Executive Director's Recommendation

Commission Meeting: November 2, 2017

PROJECT Building Exterior, Vestibules, and Site Improvements National Air and Space Museum Independence Avenue at 6th Street, SW Washington, DC	NCPC FILE NUMBER 7585 NCPC MAP FILE NUMBER 1.41(38.00)44627
SUBMITTED BY Smithsonian Institution	APPLICANT'S REQUEST Approval of comments on revised concept design
REVIEW AUTHORITY Federal Projects in the District per 40 U.S.C. § 8722(b)(1) and (d)	PROPOSED ACTION Approve comments as requested
	ACTION ITEM TYPE Staff Presentation

Delta Solar Plinth

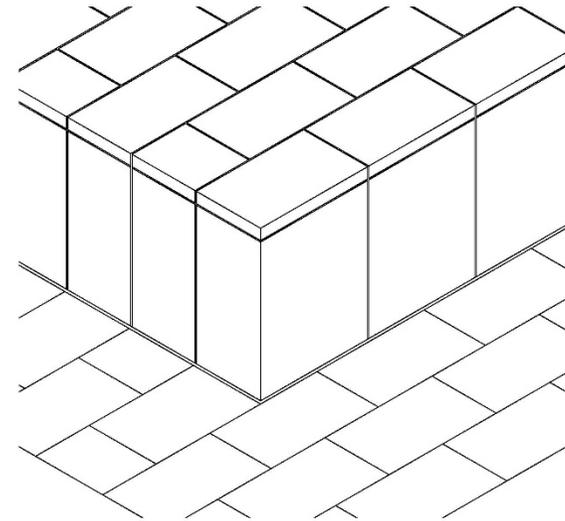
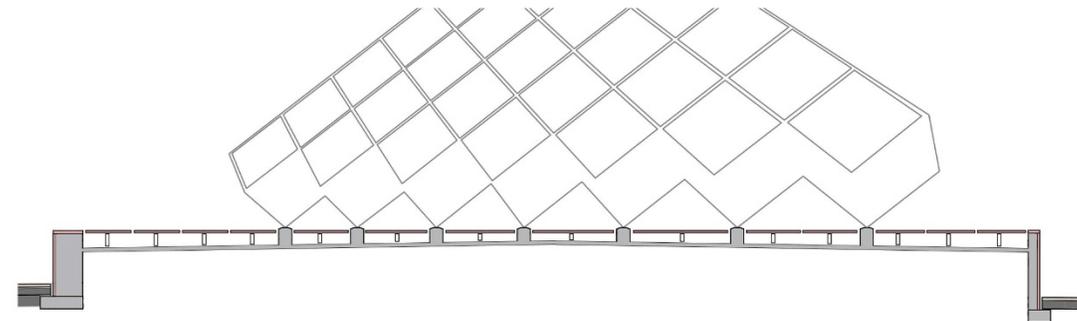
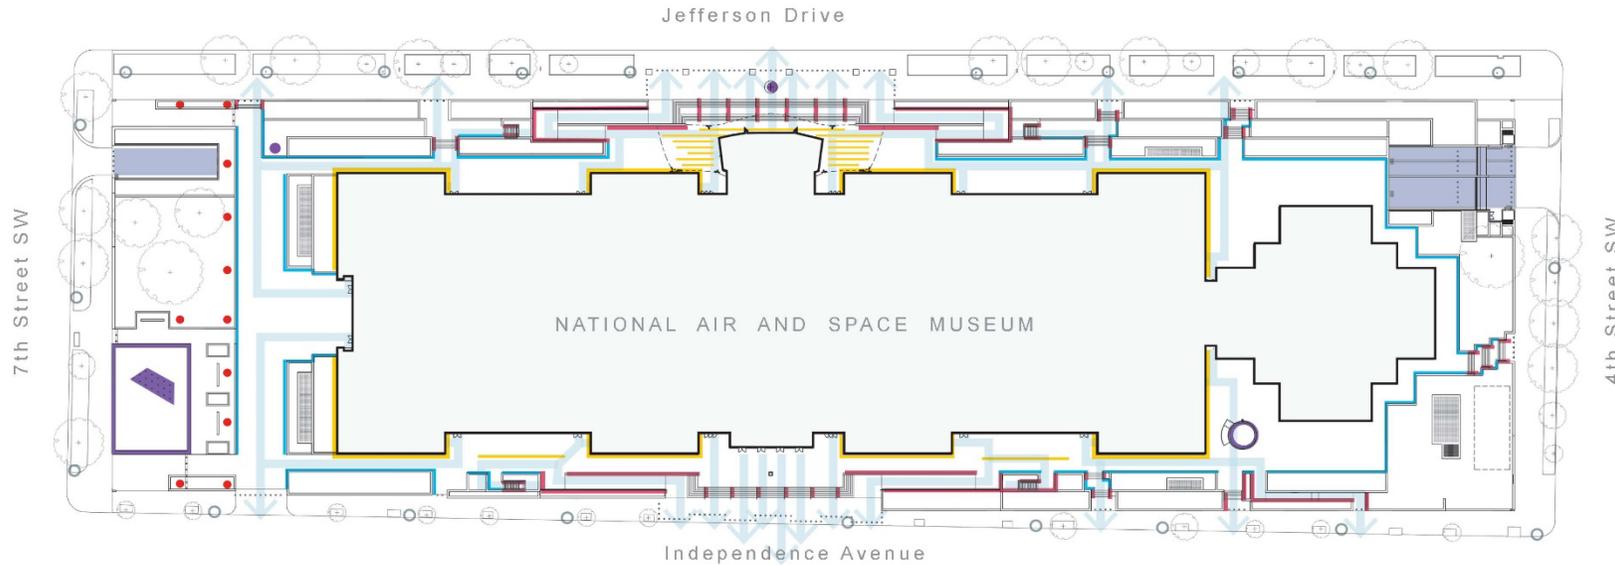
Does not support the revised configuration of the Delta Solar consisting of a dry plinth without a water feature as the sculpture base, because it does not create a welcoming entry to the museum and the National Mall, and negatively impacts the integrity of the sculpture, and therefore;

Staff finds that the paved plaza and dry plinth around the Delta Solar will decrease the amount of pervious areas on the museum grounds and contribute to the heat island effect. The dry plinth configuration also alters the setting of the sculpture and detracts from the arrival experience at this important gateway to the National Mall. As such, staff recommends the **Commission not support the revised configuration of the Delta Solar consisting of a dry plinth without a water feature as the sculpture base, because it does not create a welcoming entry to the museum and the National Mall, and negatively impacts the integrity of the sculpture.**

The relationship between the water feature and the sculpture is crucial. When the plinth is dry, staff is concerned that it will read more as piece of infrastructure, such as a perimeter security barrier or resemble the elevated metro vent shaft walls that have been installed around the city as a flood hardening measure, which are also clad in granite with a similar stone configuration. The dry plinth will overshadow the beauty of the sculpture and will not provide an appropriate pedestal for the Delta Solar. It will also introduce a visual barrier, blocking views to the museum from the corner of Independence and 7th Street without enhancing the existing conditions. The perimeter security function will dominate the plaza and the west end will continue to be unattractive and uninviting.

Requests that the Smithsonian submit a revised design for the west end plaza that incorporates the following:

- A water feature that operates year-round and maintains the relationship with the Delta Solar sculpture in a creative and sustainable manner.
- Programming for outdoor cultural events, gatherings, celebrations, and passive recreation. Flexible areas to accommodate congregating and place-making activities.
